NORME
INTERNATIONALE
INTERNATIONAL
STANDARD

60821

AMENDEMENT 1
AMENDMENT 1

**VMEbus –
Microprocessor system bus
for 1 byte to 4 byte data**

Figure 4-8 – Release of the interrupt request lines by ROAK and RORA INTERRUPTERS

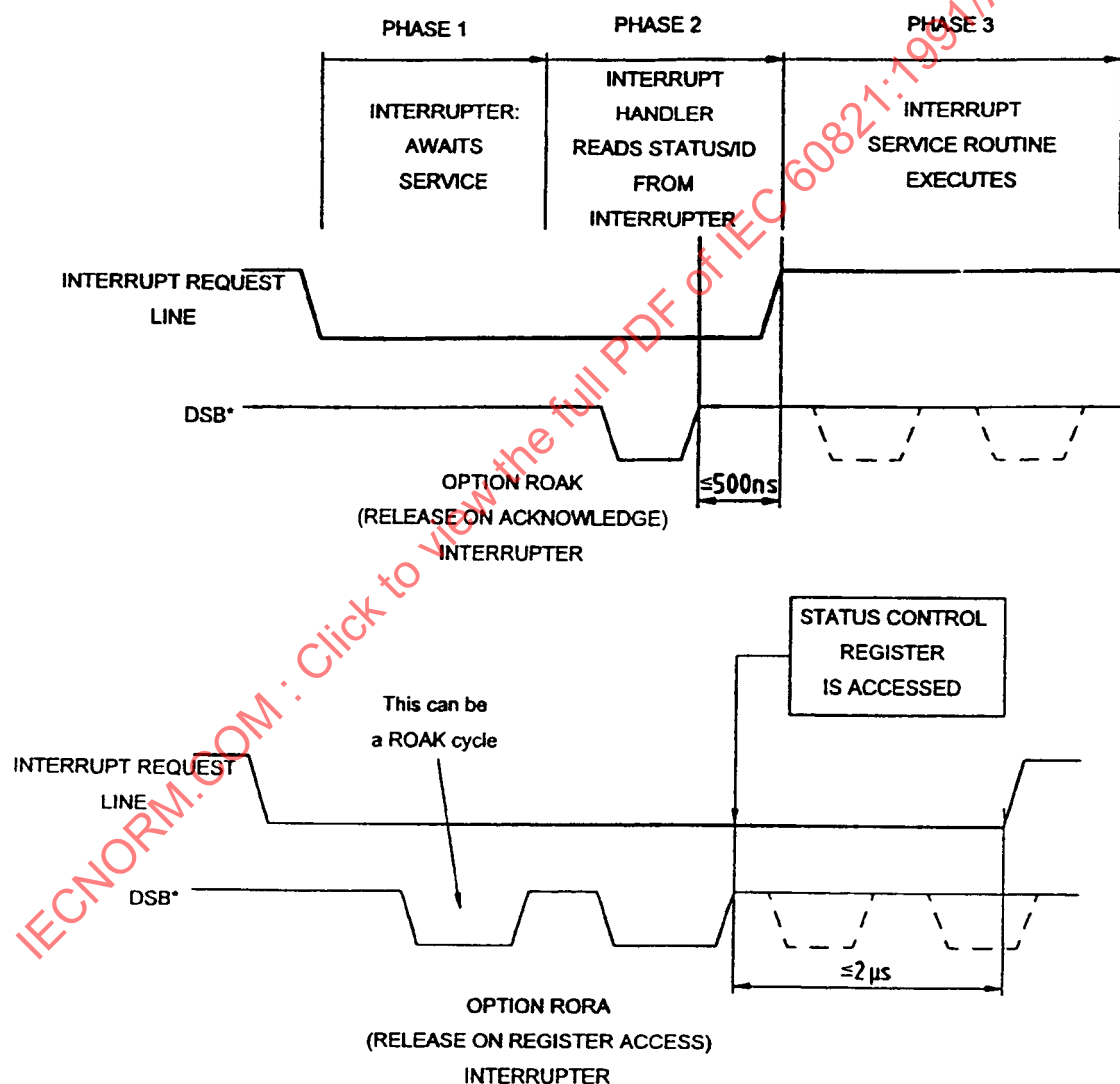
Replace figure 4-8 by the following new figure:

Figure D-5 – VMEbus arbitration structure; dashed circles indicate where critical input conditions can arise
a) simplified block diagram;
b) control signals, with evidence of the handshake loop (MASTER - REQUESTER - ARBITER - REQUESTER - MASTER)

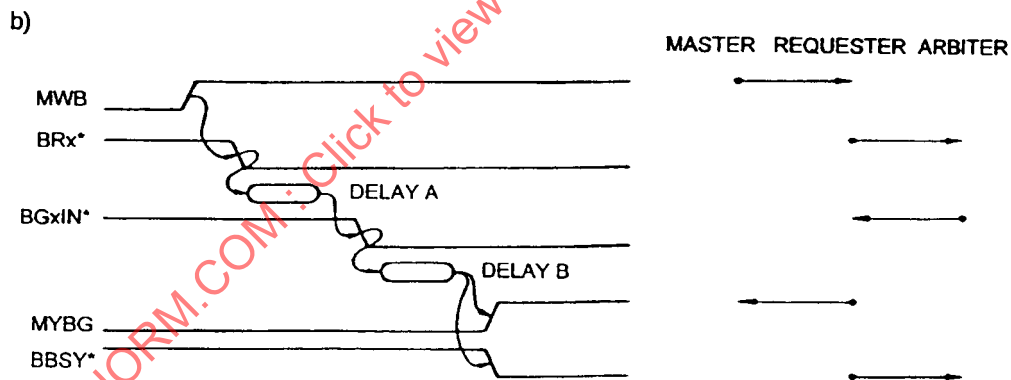
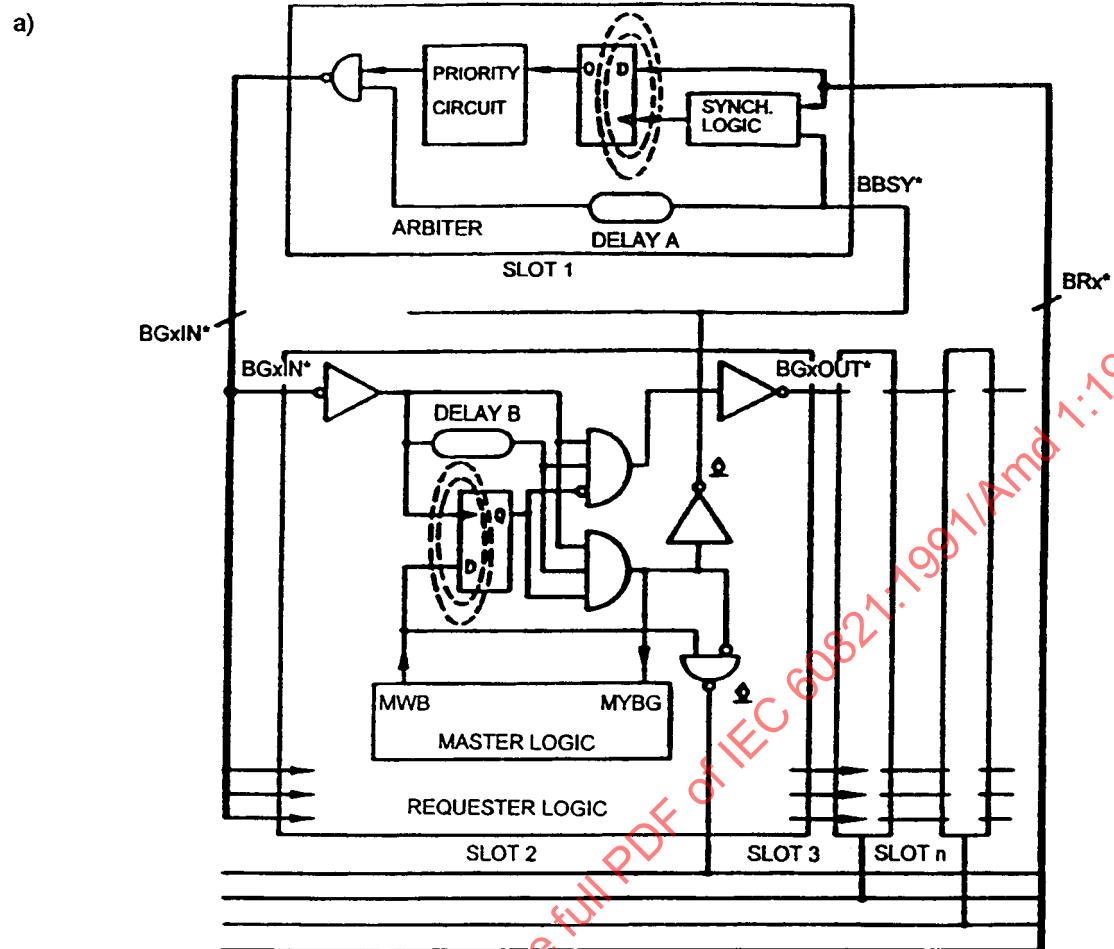
Replace, on page 527, figure D-5 by the following new figure:
